Meeting: 1/20/2022**Applicant:** Sean Bolen**Owner:** Sean Bolen

Location: 115 E. Scott Ave.**Parcel ID** 81 K F 040**District:** Old North Knoxville H**Zoning:** RN-2 (Single-Family Residential Neighborhood)**Description:** Queen Anne, c.1890, 2006

1-E-22-HZ
APPLICATION FOR CERTIFICATE OF APPROPRIATENESS

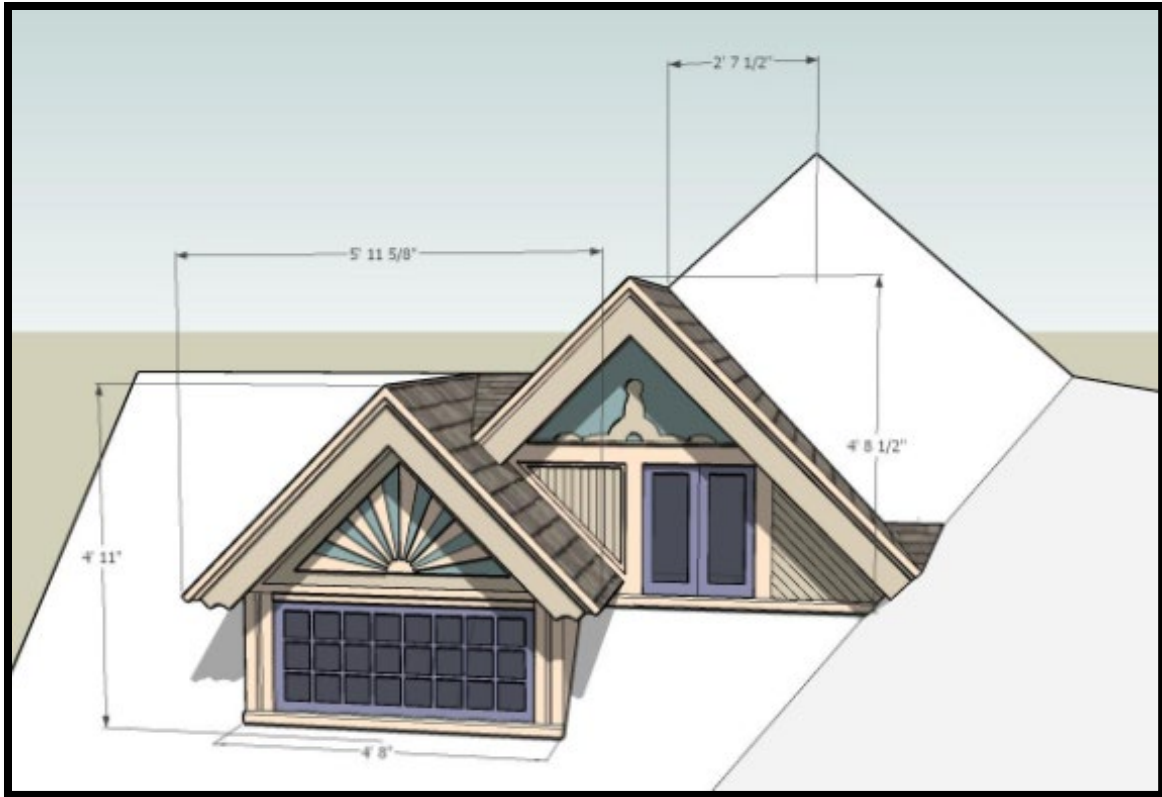
The dormer that was approved was not the one that was installed by the contractor, who rotated the angled dormer by 45 degrees and (inexplicitly) put a support post in the staircase to the third floor rendering that space difficult to complete, in addition to not providing coded headroom. The new dormers proposed rectify all situations and are inspired by George F. Barber who is thought to have designed the house. The front porch design was also inspired by Barber.

3. The revised dormers are an improvement in design over the existing front-gable roof dormer, and will draw detailing from the existing house's details. While constructing a new but historically-detailed front dormer would not necessarily be considered an appropriate modification for an original house, the house has already been divorced from its context and assessed as new construction/non-contributing. The revised dormers will be proportionate to the house and contribute to the overall design.

2. Rear Deck Addition

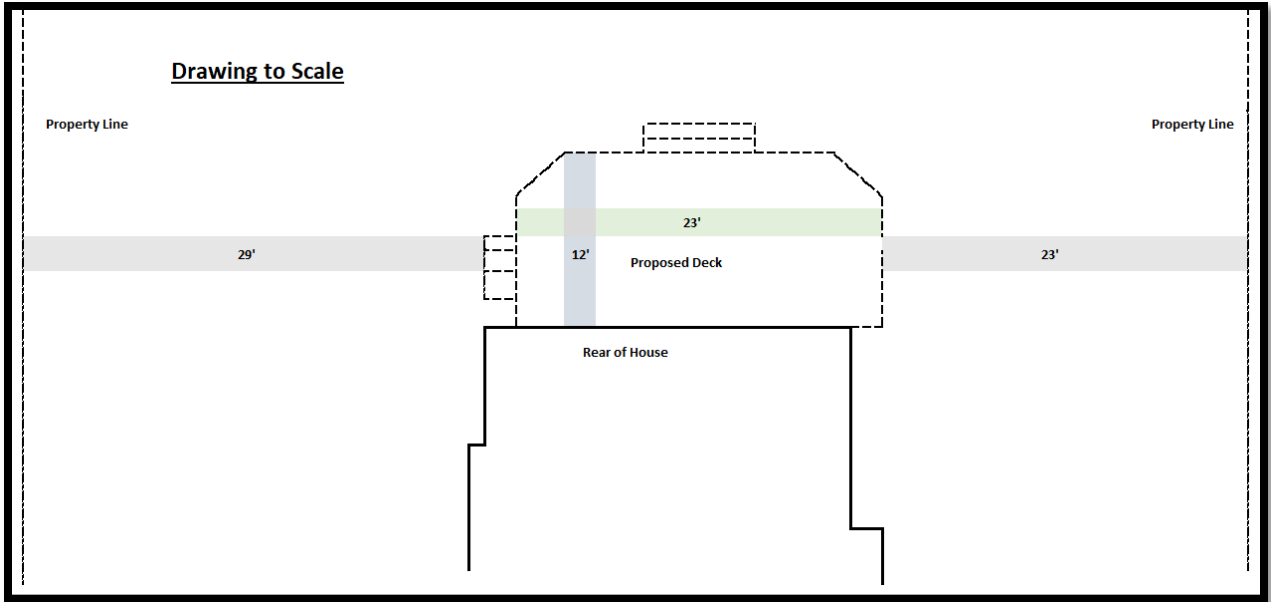
- a. The rear deck addition (23'x12') is no wider than the main body of the house and cannot be seen while directly looking at the house. This house sits on a wide lot, 75' verses 50', so the deck will be somewhat visible from the right of way from the east.
- b. The contruction will be wood with horizontal cable balisters.

4. The proposed rear deck is appropriately placed, minimal in size, and will be minimally visible from the street, if visible at all.
 5. Removal and replacement in-kind of the upper porch elements meets the design guidelines. The replacement of wood tongue-and-groove flooring with some brands of composite tongue-and-groove flooring material has been previously approved in Old North Knoxville, especially on second-story porches which are exposed to the elements. The applicant should provide the final specifications for the composite flooring material to staff for approval.
